Goldstar Fashion (ID: 22982)
Sumi Apparels (Pvt) Ltd. (ID: 9920)
Disari Poly Print & Packaging Ind. Ltd.
Disari Washing Plant

17.APRIL.2014

Identified Priority 1 Concerns

Priority 1 Concern

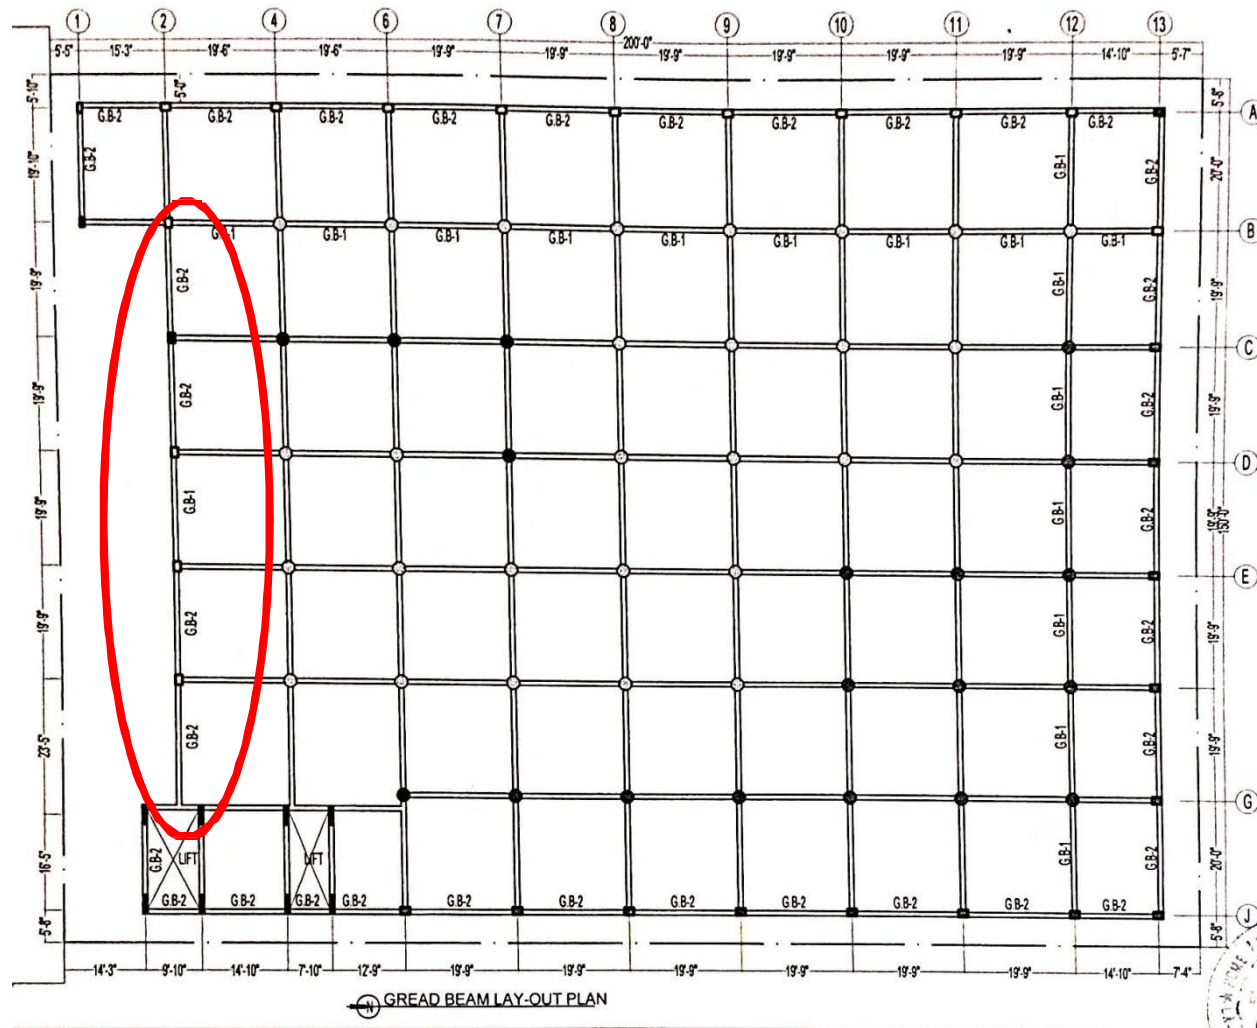
Structural drawings do not match current state or permit drawings. Cantilevers not shown. A courtyard shown on the permit drawings has been built over.

- The factory Structural Engineer stated that the columns and footings were designed for 8 floors (5 floors, 2 mezzanines, and a roof slab), however this is not shown on structural plans and plans to build more were observed.
- The Structural Engineer is to review the site conditions and modify drawings to suit existing conditions.

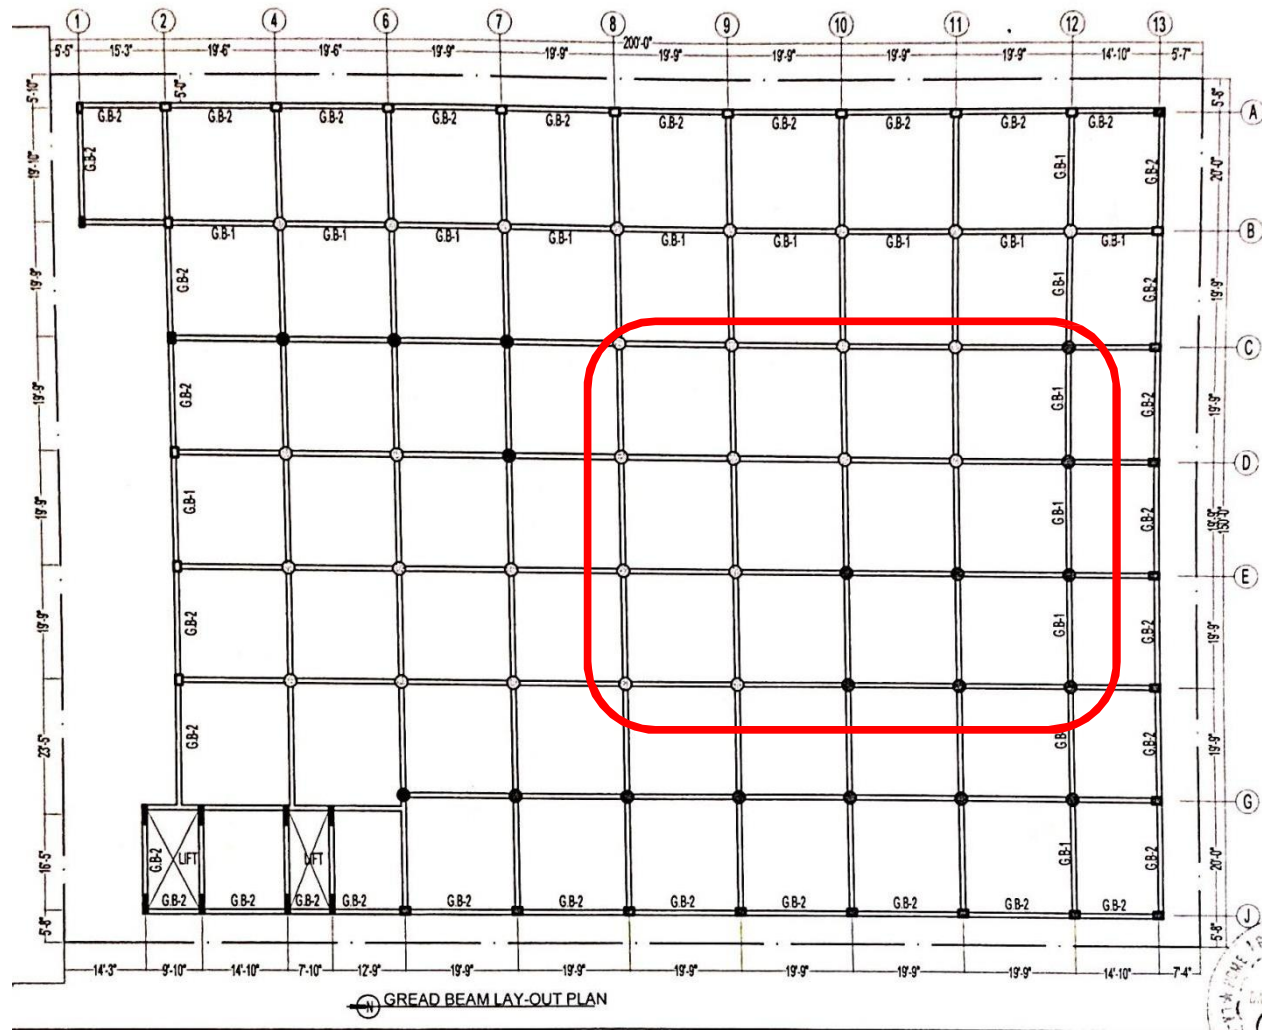
Structural drawings do not match current state or permit drawings. Courtyard shown on permit drawings has been built over. The two existing mezzanines are not shown on the permit drawings.

High storage loads on two floors. The rolls of yarn were calculated as 12kPa.

3rd Priority 1 Concern

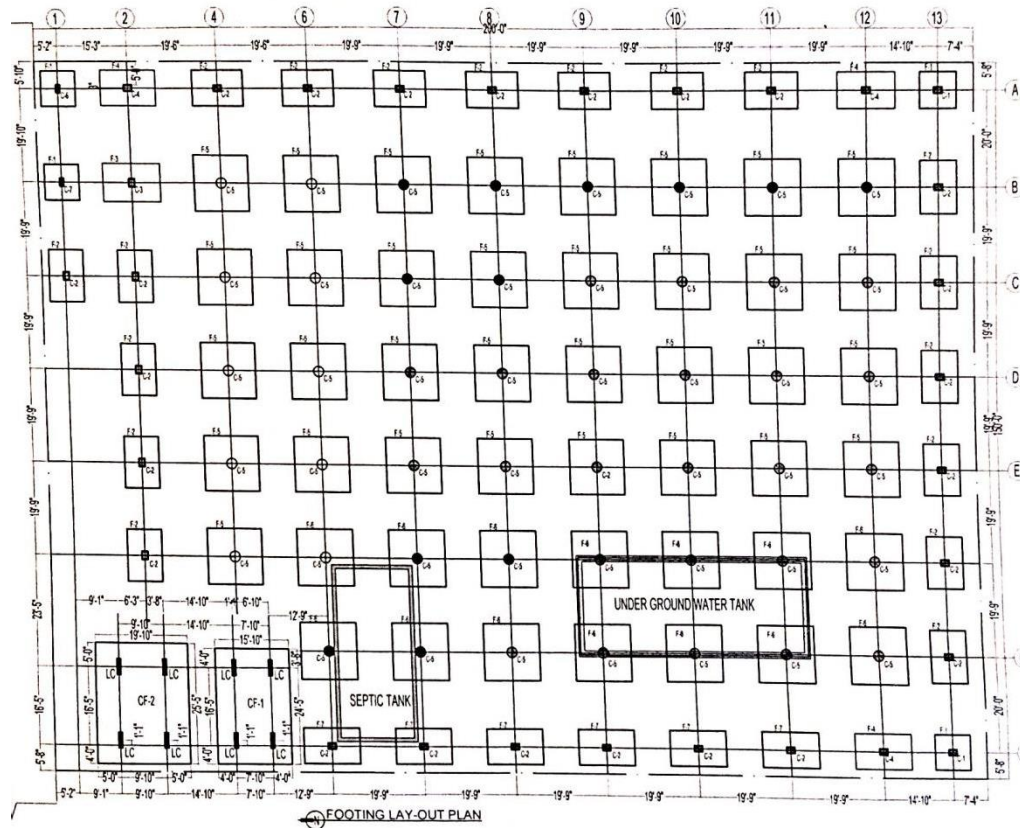
Cracking in beams, slabs and one isolated crack in column. Cracks are shown in red for clarity

- Engineering assessment be carried out to determine the cause of the cracks.

- Remedial work be carried as required to repair cracking.
